Ref: EMS067

Client: A2Dominion Development Limited
Development: 156 West End Lane
Subject: Response to further comments for the Energy Strategy

Figure A1 – Summer Design Day CHP, thermal storage and backup boiler output

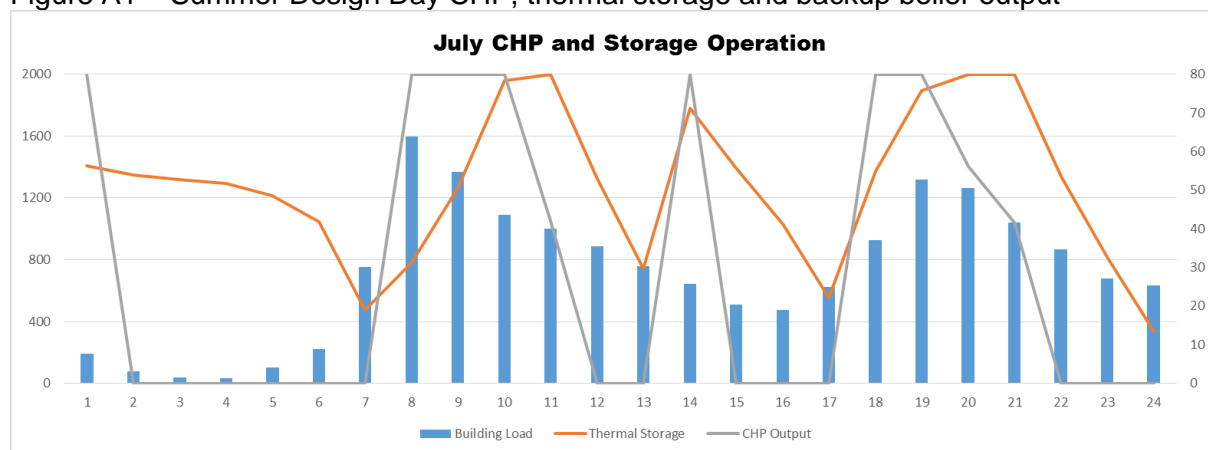
2. CHP is proposed which provides the majority of the site-wide carbon savings. This suitability of CHP for a relatively small site has been questioned by the Council and the GLA, and the developer has subsequently provided further information. There is high level of fluctuation during the summer months which is not considered to be optimal for operation. The applicant has said this is because of the interaction between the CHP meter reader and the thermal store (when the thermal storage is full the CHP slows down as the storage can meet the demand). There are multiple stop-starts of the CHP system throughout the June design day – the applicant should confirm that this type of operation is technically feasible for the development. **Further actions: There are multiple stop-starts of the CHP system throughout the June design day – the applicant should confirm that this type of operation is technically feasible for the development.**

Please find below our response from the 11th November 2016 Addendum where the starts-stops of the assumed CHP engine (one engine assumed at this stage) have been reduced. This operation is reasonable and technically feasible, as there is the preconception from CHP suppliers that if the starts-stops during a day are less than 15 and the CHP unit functions for more than 30 minutes each time, this operation is reasonable and technically feasible. The relative mail correspondence with a CHP supplier is presented in Appendix A.

There has been some further adjustment to the CHP controls in our model that resulted in a more normalised CHP operation profile during the summer months, as depicted in figure A1. During the summer design day we now have three clear periods of CHP operation and decreased fluctuation. Thus, this more steady profile is regarded as optimised for the CHP installation.

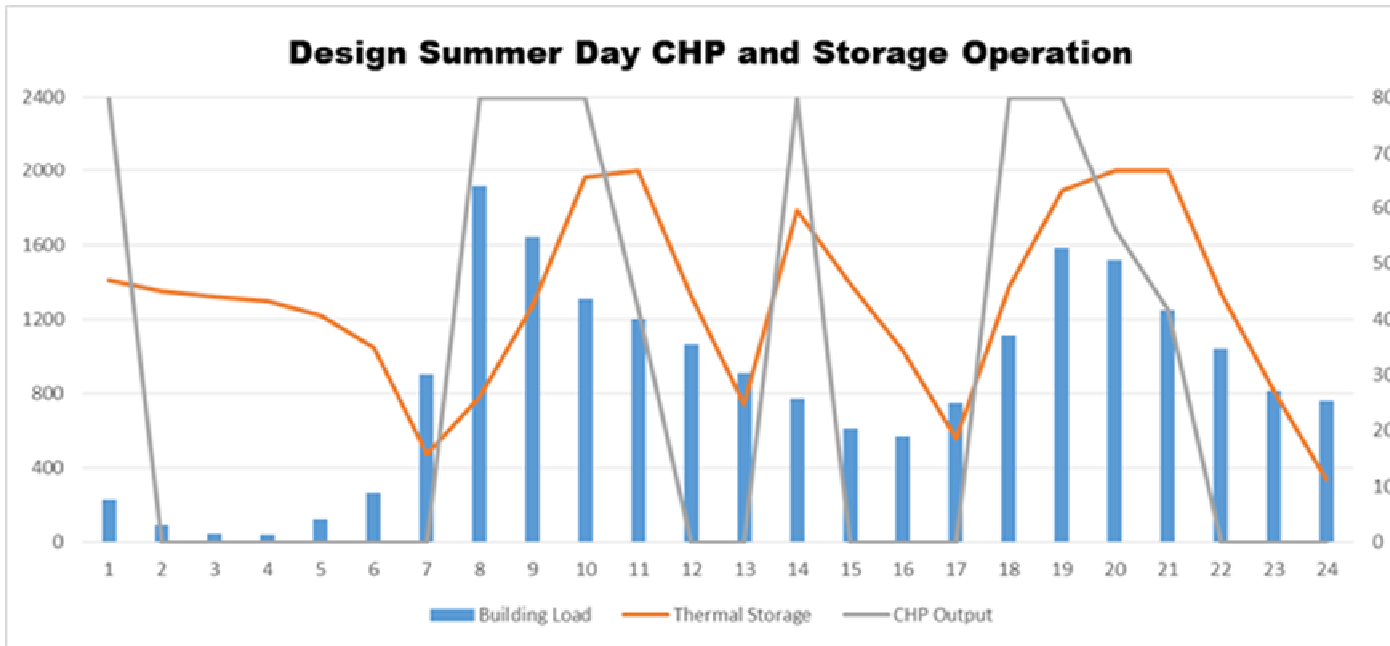
The following summer design day thermal load chart shows that the CHP unit together with the thermal storage will operate as indicated below. (assumption: one CHP unit serves the total load)

Do you consider the depicted starts and stops of the CHP engine to be technically feasible?

I can confirm that three CHP starts in 24h period are perfectly OK. A few starts per 24h are fine for LoadTracker CHP. This can be a likely scenario on numerous sites out of the heating season.

As mentioned on the phone yesterday CHP control system is trying to avoid engine short cycling which is defined by manufacturer as stop/start every 20-30 min. Such frequent starts would have negative influence on engine lifespan.
